**ADMINISTRATIVE RECORD
FOR THE MADISON SITE
MADISON, ILLINOIS**

Written Public Comments and Corresponding Responses
to Comments

SUBJECT: Transmittal of USACE Responses to IDNS Comments on the Final Madison Site Remedial Investigation/Feasibility Study and Proposed Plan, January 2000

DOSE ASSESSMENT FOR DIFFICULT-TO-ACCESS AREAS

Figure 1. Approximate Sample Locations for Difficult to Access Areas

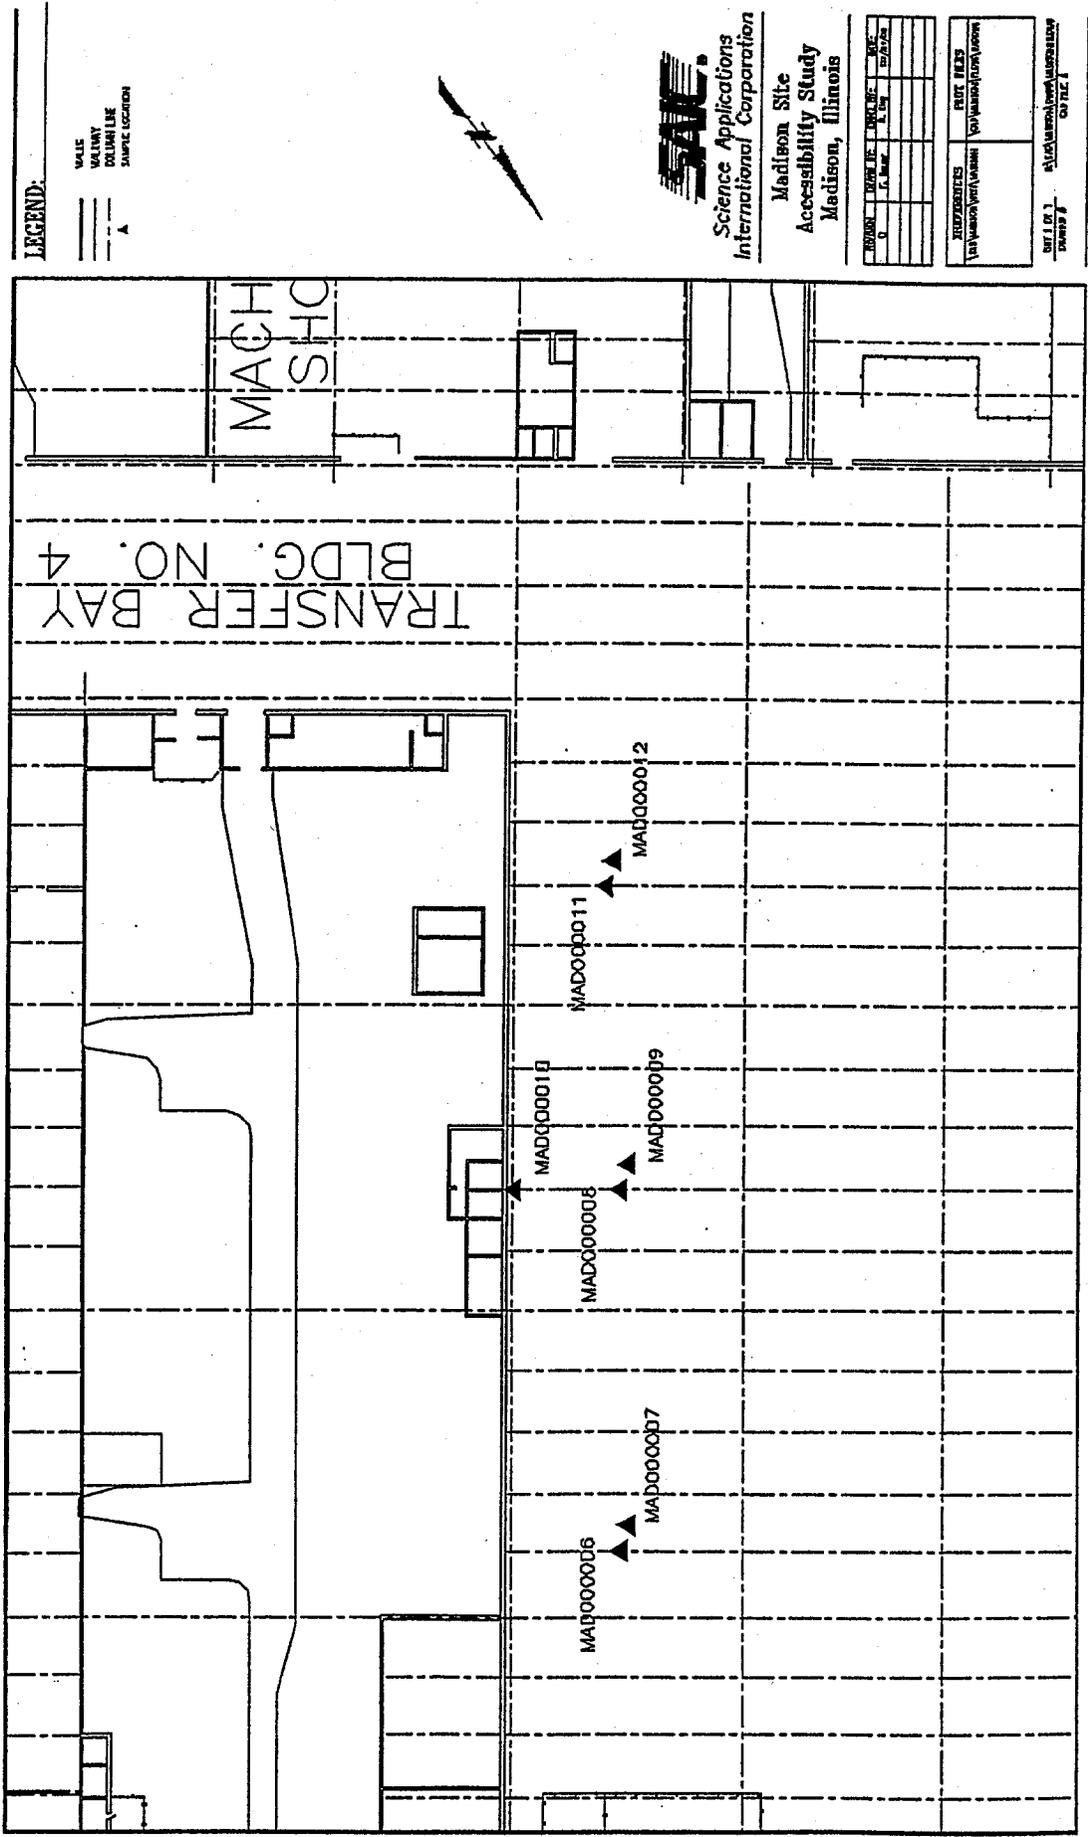
Comment 9—The Department is encouraged that the Corps has collected additional samples to further characterize contaminated areas. The first step described in decommissioning guidance is the characterization of the radioactive contamination ("source term" or "source"),

upon which all subsequent assessments are based. The Department has not been satisfied with the source characterization at the Madison facility, due to the invalidated assumptions of contamination levels at the upper tiers of the facility. The Department hopes that the Corps has now collected the samples necessary to demonstrate statistical representation of all contaminated areas. The Department is withholding a determination on this issue until the new sampling results and statistical analyses have been documented by the Corps.

Response 9—USACE has completed additional sampling and performed a supplemental risk assessment of the Difficult-to-Access Areas. The results of this assessment are enclosed. (Attachment 1).

The beam/sample locations presented in Table 1 are shown in Figure 1. Figure 1 is based on the hand-drawn map used by field personnel during the sampling event. Figure 1 is not drawn to scale, but does illustrate the distribution of sampling locations in relation to previous sampling events and the extrusion press. For a comparison to previous sampling locations and concentration results (from lower/accessible beams in the study area) see Figure 1-4 from the Feasibility Study (USACE 2000).

Figure 1. Approximate Sample Locations for Difficult to Access Areas

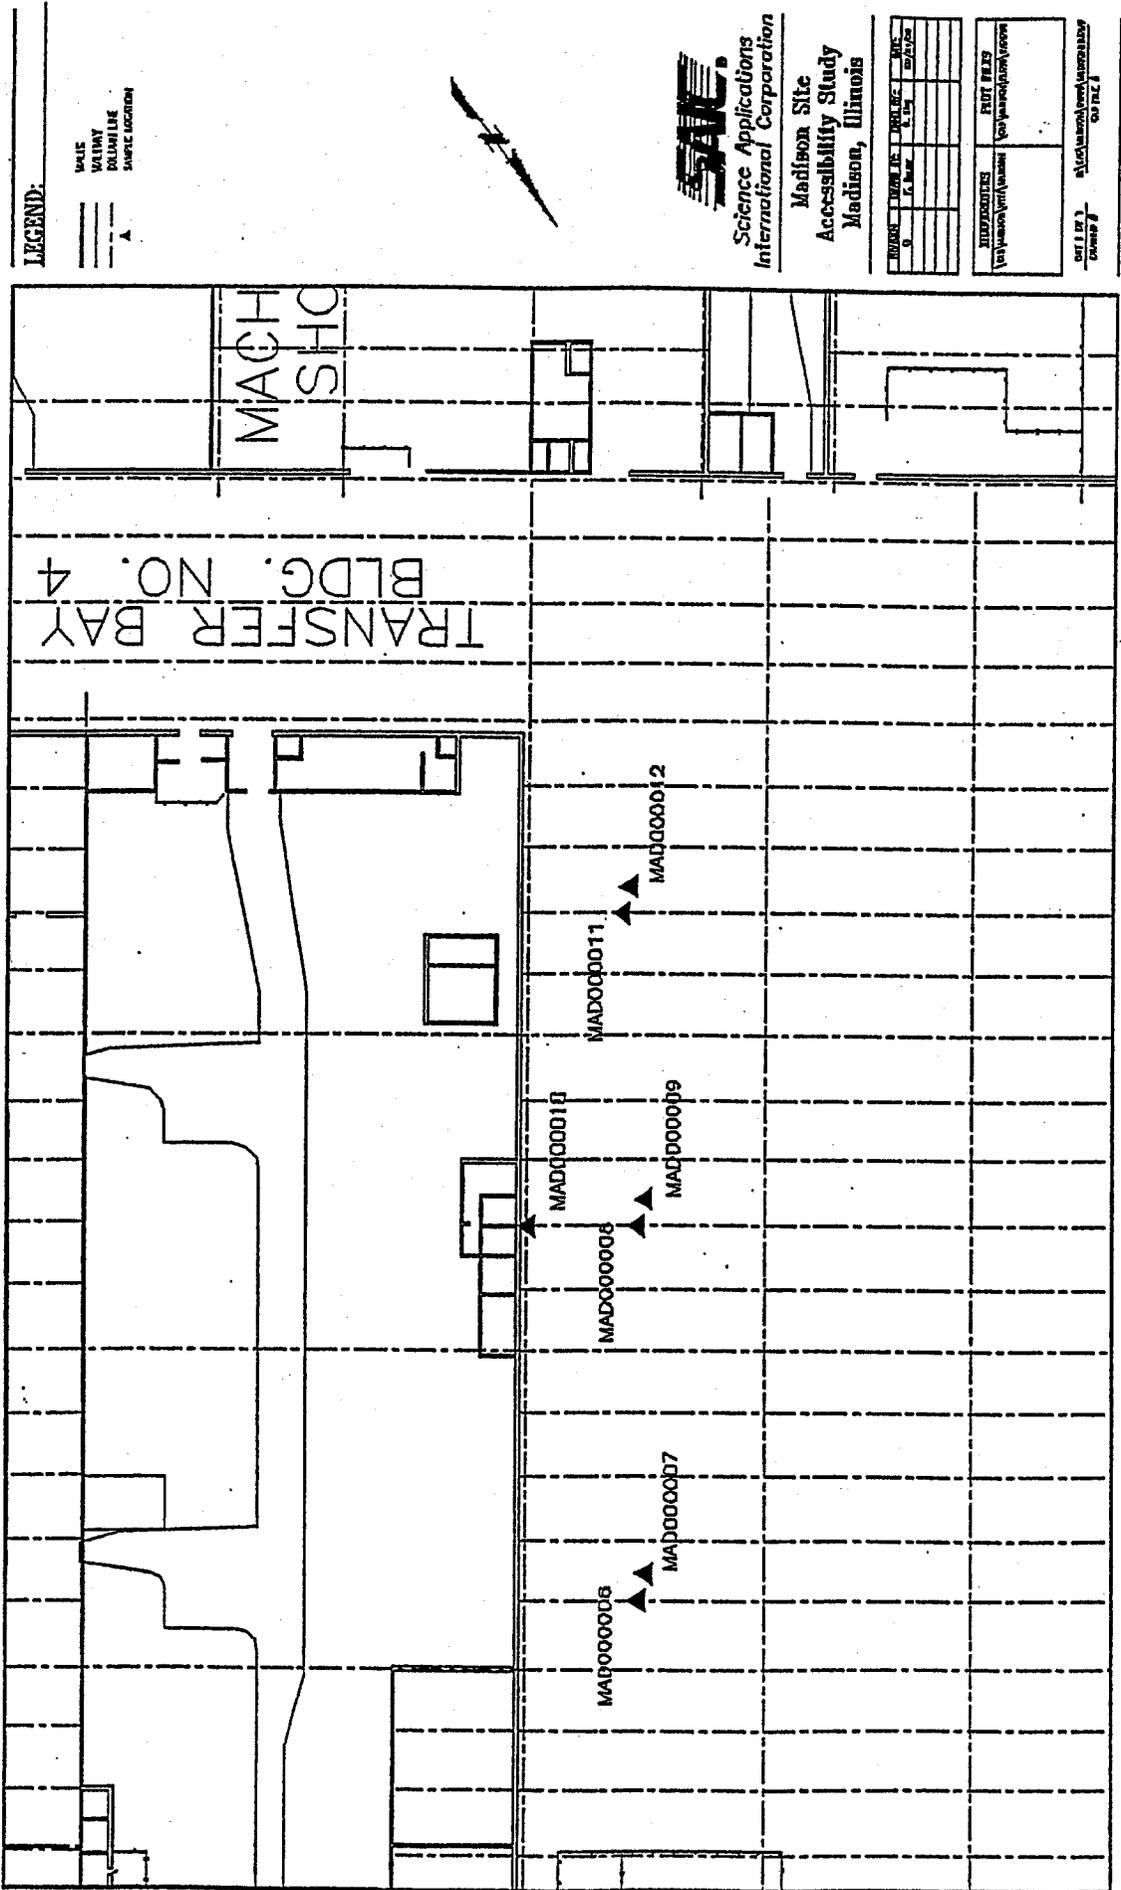
Comment 9—The Department is encouraged that the Corps has collected additional samples to further characterize contaminated areas. The first step described in decommissioning guidance is the characterization of the radioactive contamination ("source term" or "source"),

Response 9—USACE has completed additional sampling and performed a supplemental risk assessment of the Difficult-to-Access Areas. The results of this assessment are enclosed. (Attachment 1).

The beam/sample locations presented in Table 1 are shown in Figure 1. Figure 1 is based on the hand-drawn map used by field personnel during the sampling event. Figure 1 is not drawn to scale, but does illustrate the distribution of sampling locations in relation to previous sampling events and the extrusion press. For a comparison to previous sampling locations and concentration results (from lower/accessible beams in the study area) see Figure 1-4 from the Feasibility Study (USACE 2000).
